Indication change of Packing label

We would like to inform that we will change the Packing label of Optional plug-in module for Electronic Multi-Measuring Instrument.

Product name	Model name
Optional plug-in module	ME-0000BU-SS96, ME-0000BU25-SS96

Items	Box type	Before change	After change
Packing label	Individual packaging		
	Multiple packaging

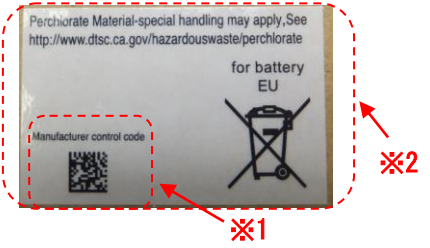
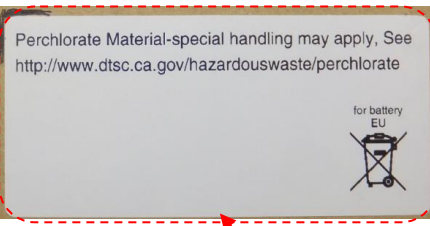
The packing label will be changed for the purpose of enhancing traceability.

※1 : Manufacturer control code is added.

※2 : The label size is changed.

※3 : The company name and address are deleted. (Printed on the box instead)
